APPEAL APPLICATION

Regarding Case Number: AA-2015-0777-PMLA-SL-1A ENVIRONMENTAL CASE ENV-2015-0778-MND IN RELATION TO 7D

Project Address: 1324 QUINTERO ST

RE: 1324 QUINTERO ST. / ENV-2015-0778-MND / AA-2015-777-PMLA

FIGURE B (EXISTING PREVAILING SETBACKS)

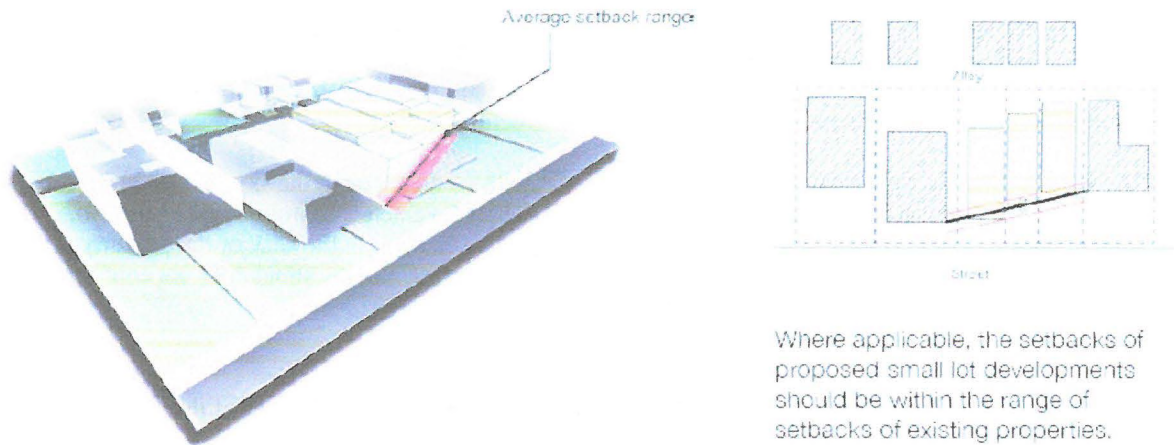
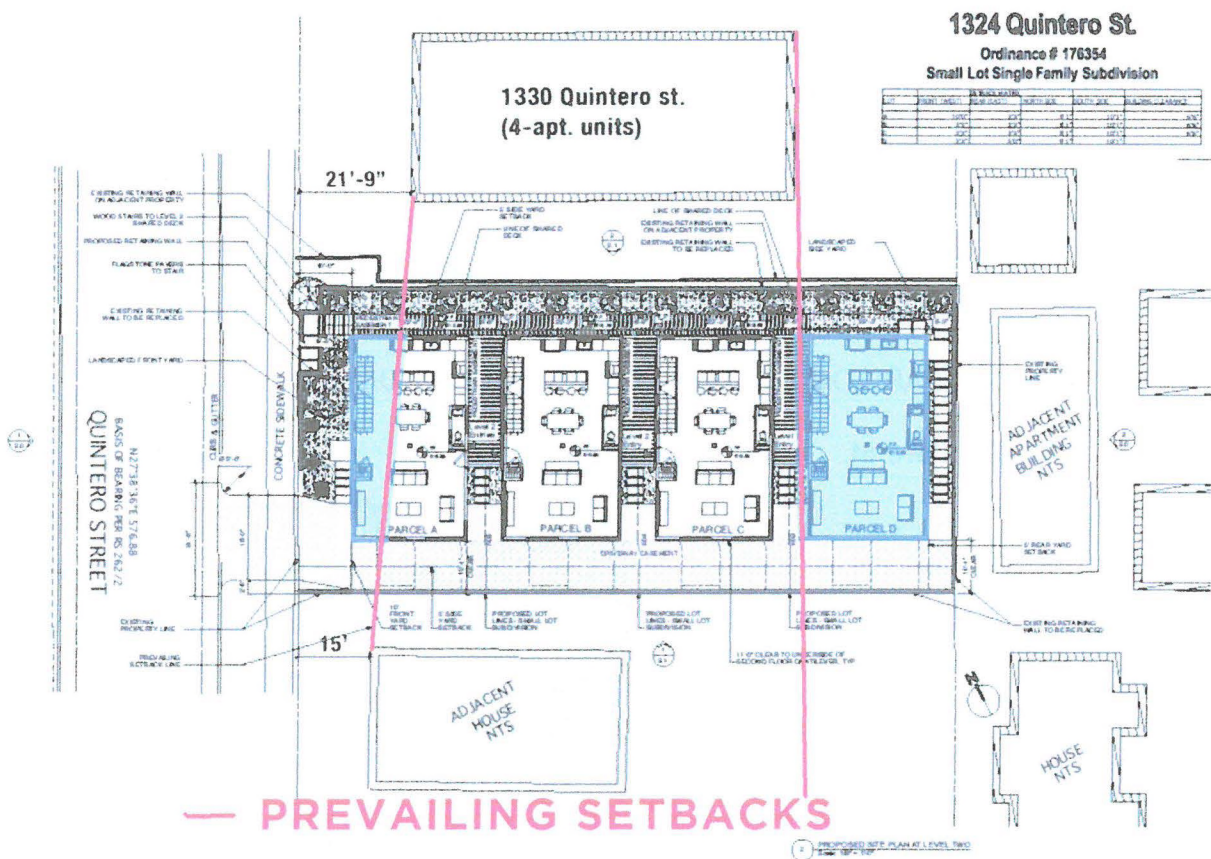
SETBACKS – The determination letter of the (Project) states that "The map does NOT comply with the 15ft front yard setback requirement." Setbacks have not been calculated in compliance with the LAMC zoning regulations. The small lot ordinance does not exempt small lot projects from basic zoning requirements of the RD1.5 zone with regard to front yards. The small lot ordinance allows for no setbacks "between lots" but is silent on the front yard setback, which then defaults to the RD1.5 zoning. If the intention was to allow small lots to violate the front yard requirement, the small lot ordinance would have stated that clearly, but it did not. However, this Deputy Advisory Agency has determined, in his sole discretion, that this project is allowed to deviate from those requirements. Therefore, this project requires a variance if it wishes to build further to the front than the underlying zoning allows. Currently, an amendment to the Small Lot Ordinance is being proposed by the city to enforce the prevailing minimum front and rear yard requirements. The Advisory agency should take the spirit of this amendment into consideration and require a 15 foot front setback to the (Project).

The existing, adjoining properties have front setbacks that range between 15ft-21ft. and minimum rear setbacks of at least 20ft (see Figure A). (The Project) has obtained a variance for a 10ft front yard setback and a 5ft rear yard setback. This does not conform with the prevailing codes, the visual characteristics of the neighborhood and will cause the building to protrude in an unsightly way past its adjoining neighbors.

FIGURE D (COMPARISON TO EXISTING ADJOINING PROPERTY)

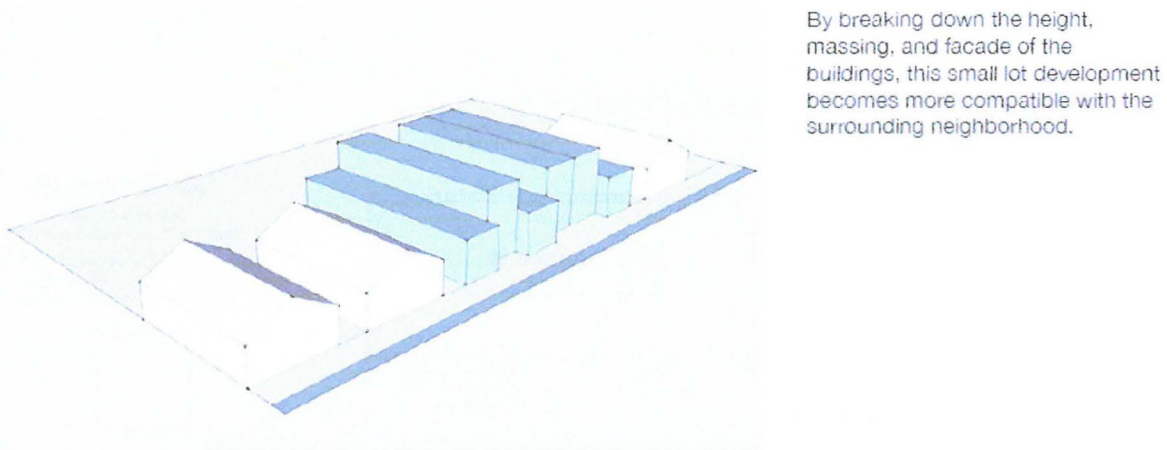
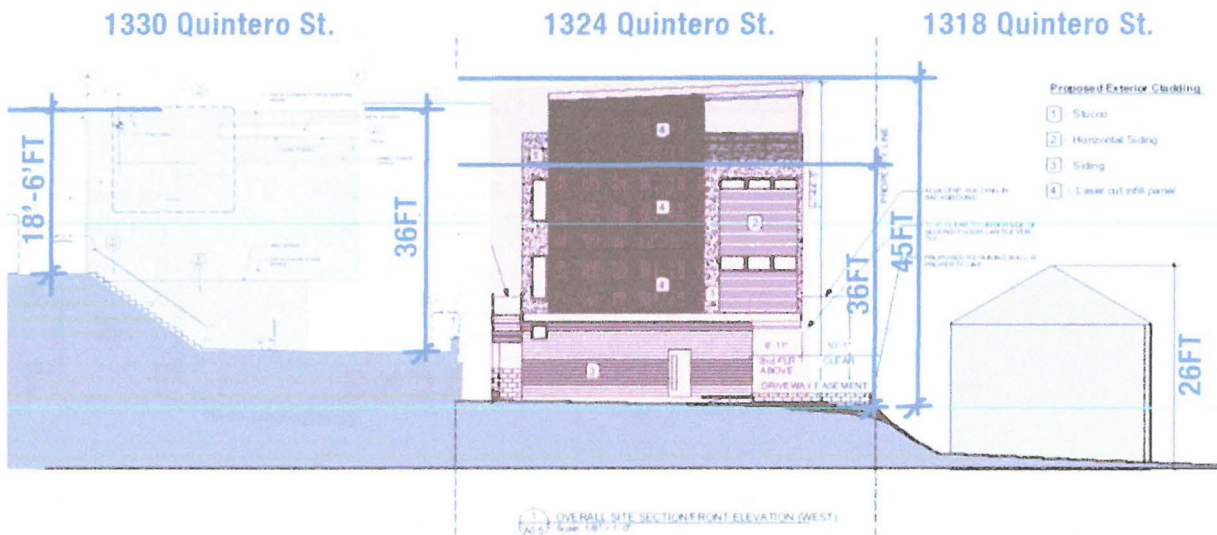
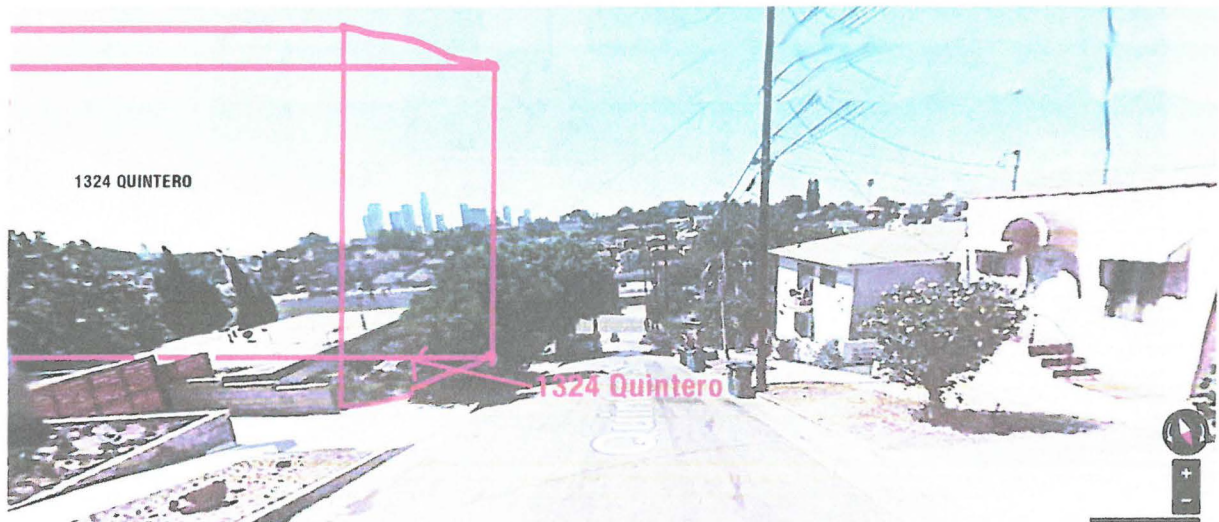
HIEGHTS – The Project proposes to build (4) 45ft tall, 4-story homes in a neighborhood that has adhered to 36ft maximum building heights. (The Project) would be substantially taller than it’s adjoining properties and the

neighborhood as a whole (see Figure C & D)
